Access Compliance Report

Public Rights-of-Way

(Curb Ramps)

Intersection ID: 48058	Main Street: FERRELL_AV	Cross Street: KEENER_RIDGE_RD	Location: SE
ADA ID: 3F9082DC036D	Ramp Type: Perp	Initial Pass/Fail: Pass	Overall Compliance: No
Codes/Mitigation Info/Possible Solution		Field Measurements/Component Compliance	
Severity Score: 5.25

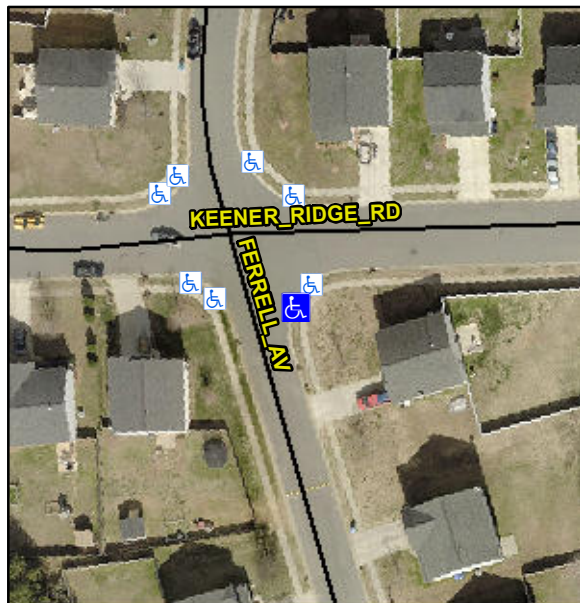
**Not Found, R304.5.3, R304.2.2-Perp,
R304.3.2-Para, R304.5.4**

Compliance	Description	Data	Compliance	Description	Data
N/A	Ramp Length (in)	47.0	Yes	Ramp Slope (%)	6.0
Yes	Ramp Width (in)	48.0	No	Ramp XSlope (%)	4.6
N/A	Flare Type LT	Sloped	N/A	Flare Type RT	N/A
N/A	Flare Slope LT (%)	2.2	Yes	Flare Slope RT (%)	5.4
N/A	Flare Traversable LT?	Yes	N/A	Flare Traversable RT?	Yes
Yes	Landing Length (in)	48.0	Yes	DWS Provided?	Yes
Yes	Landing Width (in)	49.5	Yes	DWS Contrast?	Yes
No	Landing Slope (%)	3.2	Yes	DWS Length (in)	25.0
No	Landing X Slope (%)	4.8	Yes	DWS Full Width?	Yes
N/A	Landing Curb? (Y/N)	No	Yes	DWS Offset (in)	2.0
N/A	Shared Landing?	No			
Yes	Gutter Ponding?	No	No	Gutter Slope (%)	13.6
Yes	Gutter Lip Ht (in)	0.0	No	Gutter X Slope (%)	5.7
N/A	Painted X Walk1?	No	N/A	Painted X Walk2?	N/A
	X Walk 1 Direction	To W		X Walk 2 Direction	N/A
N/A	X Walk 1 Width (in)	N/A	N/A	X Walk 2 Width (in)	N/A
	X Walk 1 Slope (%)	3.5		X Walk 2 Slope (%)	N/A
	X Walk 1 X Slope (%)	2.4		X Walk 2 X Slope (%)	N/A

**Remove & Replace Entire Ramp.
Remove & Replace Gutter.**
